SUBJECT: EXEMPTION FROM 10 CFR 72.48, 10 CFR 72.212 AND 72.214 FOR DRY
SPENT FUEL STORAGE ACTIVITIES - FORT CALHOUN (TAC NO. L23984)

SAFETY EVALUATION REPORT
EXEMPTION FOR
OMAHA PUBLIC POWER DISTRICT
FORT CALHOUN STATION
INDEPENDENT SPENT FUEL STORAGE INSTALLATION
DOCKET NO. 72-54

Figure 1 - Supplemental Shielding in Decontamination Area

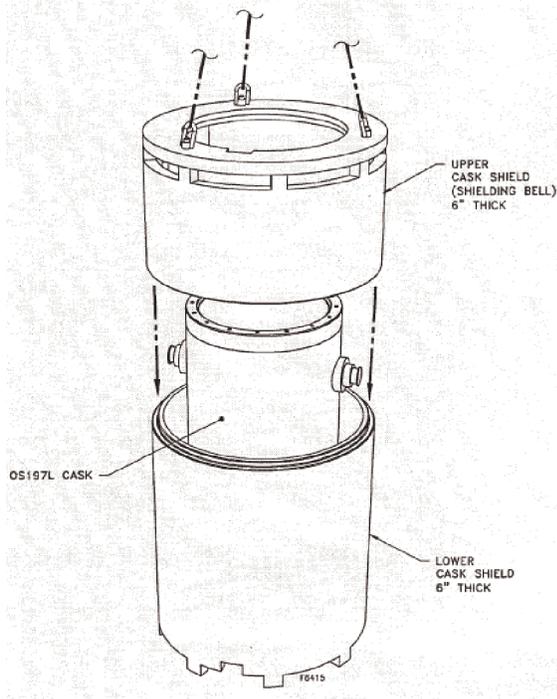
The supplemental shielding used in the decontamination area and on the transfer trailer is not part of the OS197L TC. Therefore, the staff does not agree with the applicant's assertion at the bottom of page 14 of Attachment 1 to the exemption request: "The radial shielding of the OS197L TC, including the decon area sleeve/bell, is documented in FCN 321, Rev. 1 [Attachment 1 of OPPD's exemption request], showing that the OS197L TC system

In general, due to the potential for high dose rates in the vicinity of the TC during off-normal operations (if that condition were to occur when the TC was not within either of the supplemental shields), the staff concludes that the OS197L TC is not an optimum solution from a shielding and dose perspective. However, the staff recognizes the constraints placed upon the applicant and agrees that with the revised TS, the planned use of remote operations when the TC is outside of the supplemental shielding, and adherence to the radiation protection provisions included in the operating procedures in section M.8.1 of the FSAR the applicant is meeting the ALARA objective of TS 1.2.11.

Figure 2 - Supplemental Shielding on Transfer Trailer

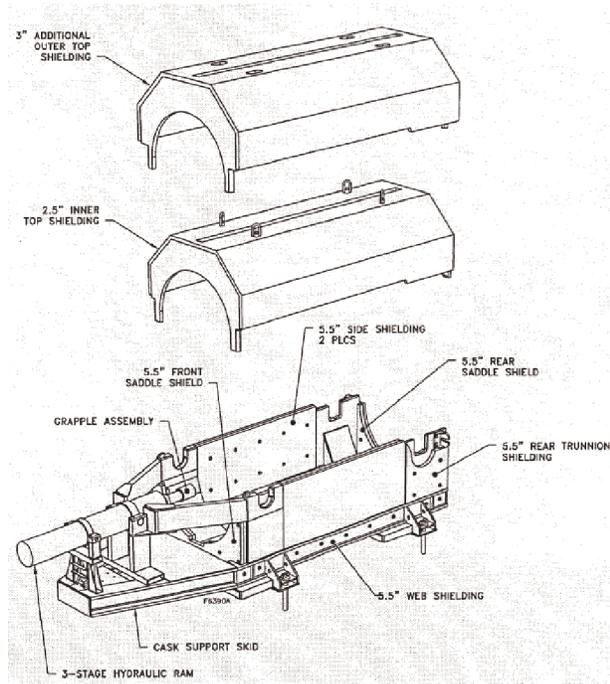
OPPD maintains that the 80-inch unrestricted drop analysis provided in the updated FSAR bounds accidents involving the transfer trailer shielding. The following two scenarios involving the transfer trailer shielding were addressed in the RAI and in OPPD's RAI response: 1) dropping of the 3-inch thick trailer outer top shield on the transfer cask, and 2) the impact the additional transfer trailer shielding would have on the 80-inch unrestricted drop analysis discussed in the updated FSAR.

failure-proof crane, dropping of the 2.5-inch thick trailer shielding does not have to be postulated. However, the 3-inch thick outer trailer top shield is placed using a non-single failure proof crane outside of the auxiliary building. OPPD states that the lift height of the 3-inch thick shielding will be administratively limited by procedure. In the response to RAI-4, OPPD evaluates the dropping of the 3-inch thick outer top shield and concludes that if it did drop it would contact the 2.5-inch thick inner top shielding and the load would be transferred directly to the skid/trailer, and then into the four 75-ton trailer jacks. OPPD maintains that the TC would not be affected by such a drop and the dropping of the 3-inch thick shielding is bounded by the updated FSAR evaluation of an 80-inch unrestricted drop of the TC. The staff agrees that the 80-inch drop analysis bounds the dropping of the 3-inch thick trailer outer top shield and therefore, dropping of the 3-inch thick shielding does not create the possibility of a new accident that requires prior NRC approval.

Regarding the impact that the transfer trailer shielding would have on the 80-inch unrestricted drop analysis, OPPD committed to adding a discussion through a FCS specific 72.212 evaluation prior to fuel handling. This discussion would be added to section W.11.1.3 of the updated FSAR and provides reasons for why any inclusion of additional structures, such as the skid, trailer, or shielding will only reduce the drop distance and will provide additional energy absorption, thus reducing the DSC g-levels in the analyzed 80-inch unrestricted drop analysis. The staff agrees that it is appropriate to add this discussion to the updated FSAR and also agrees with the conclusion that the 80-inch unrestricted drop analysis bounds accidents involving the transfer trailer shielding. The staff concludes that the transfer trailer shielding, therefore, does not create the possibility of a new accident that requires prior NRC approval.
